EVANSTON SHORELINE REPAIRS

PUBLIC OPEN HOUSE #3 SUMMARY

AUGUST 29, 2023 6PM

SHERIDAN ROAD – 10 COMMENTS (INCLUDES EMAIL RESPONSES)

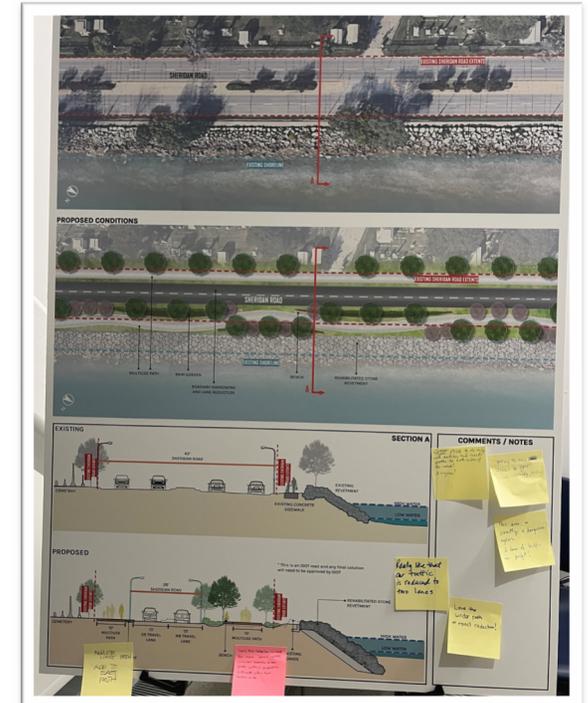
- (5 Comments) Like idea of reducing road.
- (2 Comments) Like how plans provide more people space.

- (1 Comment) Consider separating bikes and pedestrians.
- (1 Comment) Consider reducing path west of Sheridan and widen path east of Sheridan.
- (1 Comment) Consider a traffic study prior to advancing plans.

LEE STREET BEACH AND ELLIOT PARK – 23 COMMENTS (INCLUDES EMAIL RESPONSES)

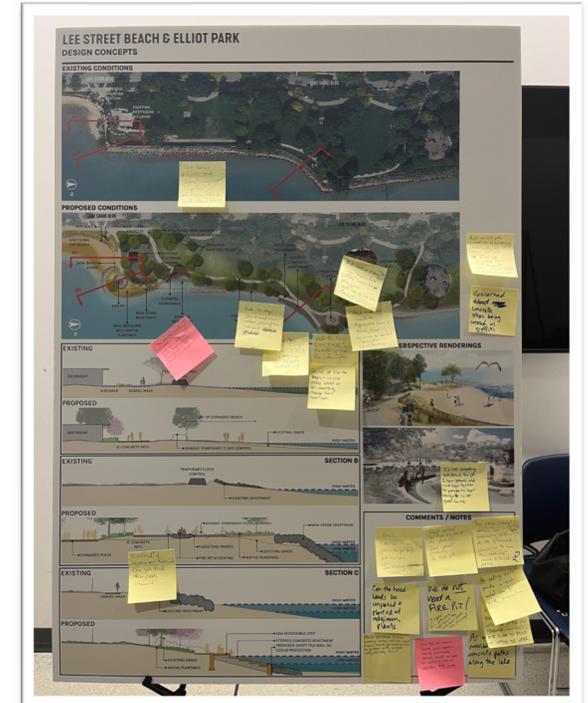
- (3 Comments) Like the addition of more seating.
- (2 Comments) Like the concrete stepped revetment.
- (2 Comments) Like the addition of places to view the water.
- (1 Comment) Like the improved access to the restroom and beach.
- (1 Comment) General approval of the concept.
- (1 Comment) Like addition of plantings around the bathroom facility.

- (3 Comments) Consider reducing pavement and increasing naturalization where possible.
- (1 Comment) Consider moving nature play to a different park that has no playground.
- (1 Comment) Consider creating more private seating spaces.
- (1 Comment) Consider separating bikes and pedestrians.
- (1 Comment) Consider changing the fire pit to something different.
- (1 Comment) Consider moving the fire pit to the other headland location

- (2 Comments) Do not like the fire pit.
- (2 Comments) Do not like the concrete stepped revetment.
- (1 Comment) Do not like the addition of too much pavement.

GREENWOOD AND DEMPSTER BEACH – 9 COMMENTS (INCLUDES EMAIL RESPONSES)

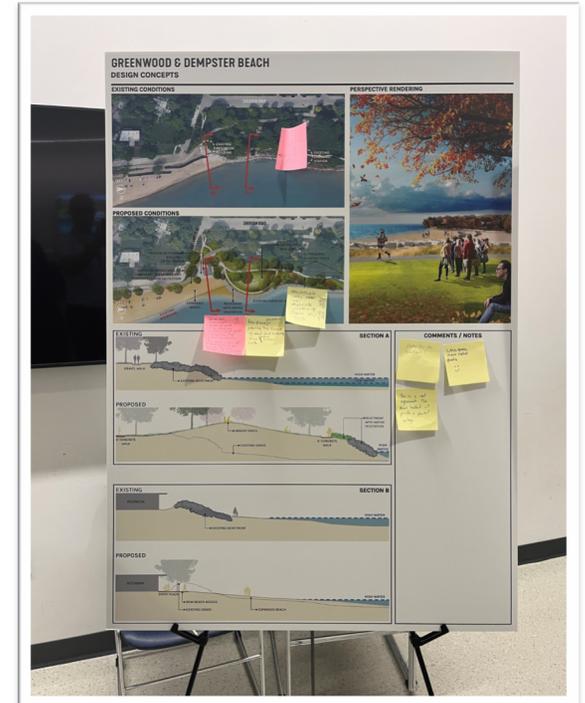
- (2 Comments) Like the headland and the new views of the lake.

- (5 Comments) Consider moving the headland north to avoid conflict with a portion of the sandy beach.
- (1 Comment) Consider replacing portions of grass with native plants.
- (1 Comment) Consider replacing the grassy knoll with a firepit.
